HISTORIC AND DESIGN REVIEW COMMISSION

HDRC CASE NO: 2016-043
ADDRESS: 2809 BROADWAY
LEGAL DESCRIPTION: NCB 6297 BLK LOT 99 THRU 140
ZONING: R6 HS RIO-1
CITY COUNCIL DIST.: 1
OWNER: City of San Antonio - Parks & Recreation Department
TYPE OF WORK: Installation of shade structures
REQUEST:

The applicant is requesting a Certificate of Appropriateness for approval to erect three 22' tall shade structures at Lions Field Park.

CUSTOMER:
CITY OF SAN ANTONIO
PROJECT NAME:
LIONS FIELD PARK
LOCATION:
SAN ANTONIO, TX
STRUCTURE TYPE:
HYPAR SAIL
SIZE:
42' x 42' x 16'-22'ø

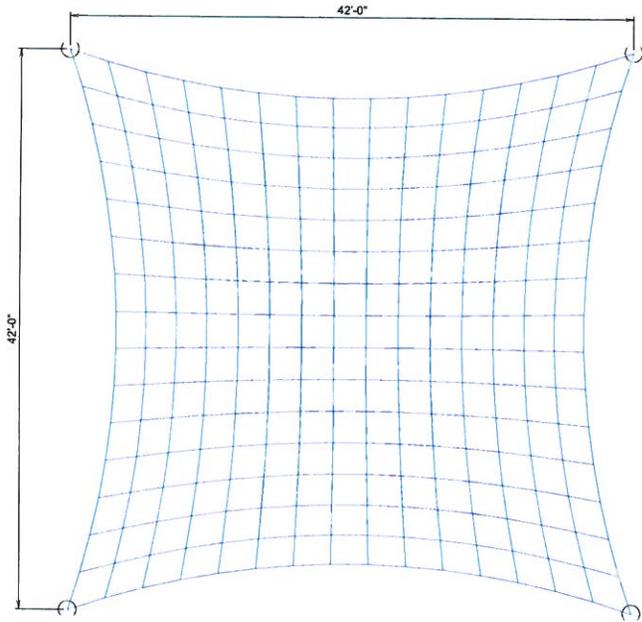
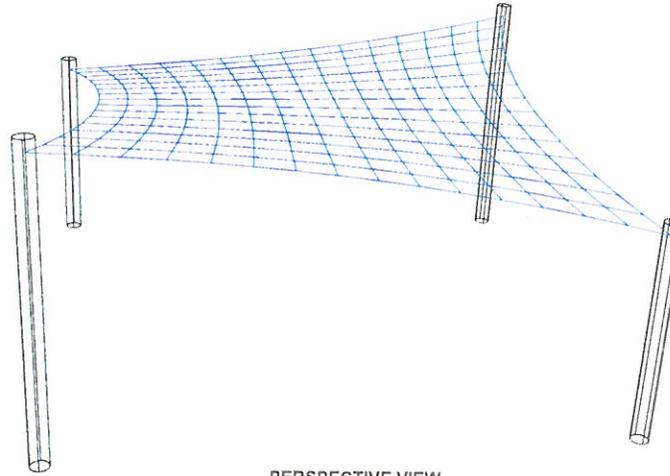
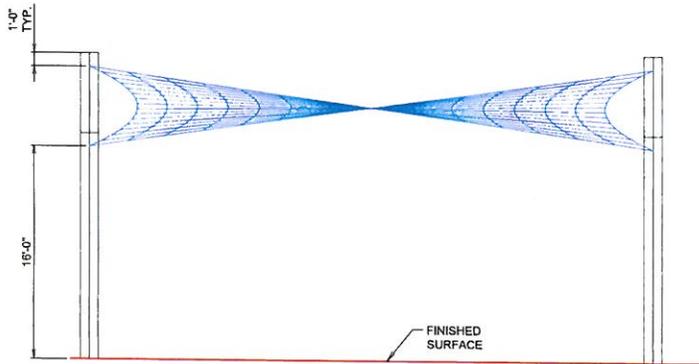
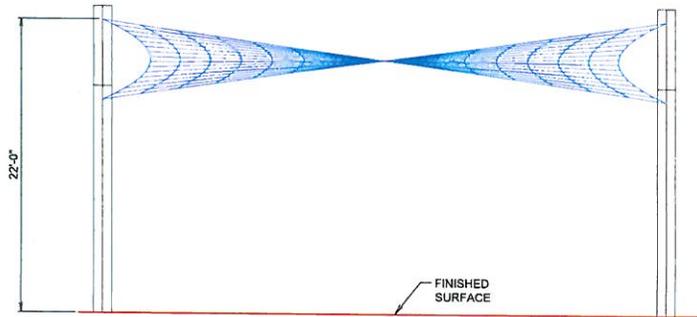
- a. The applicant is proposing to erect three shade structures to cover the playground equipment at Lions Field Park. Each sail will be blue in color and made of a 42' x 42' synthetic Shadesure Fabric and held up by two 16' and two 22' steel poles.

- b. The Lions Field Park abuts Brackenridge Park to the east. Design objectives for "RIO-1" in Sec 35-670 of the UDC are to maintain scenic open space and the natural character of the river, particular though Brackenridge Park. Staff finds that the installment of the shade structures do not detract from the character of the river or Brackenridge Park and maintain open space.

- c. ARCHAEOLOGY-The property is located within the River Improvement Overlay District and the Brackenridge Park National Register of Historic Places District. Moreover, the project area is in close proximity to previously recorded archaeological sites 41BX1396, 41BX321, and 41BX1953. Therefore, archaeological investigations may

be required. If the proposed work includes any deep (over 1') excavations, then archaeological monitoring will be required.

Staff recommends approval of requests as submitted based on findings a through b with the stipulation that an archaeological investigation will be required if the aforementioned stipulations are exceeded.
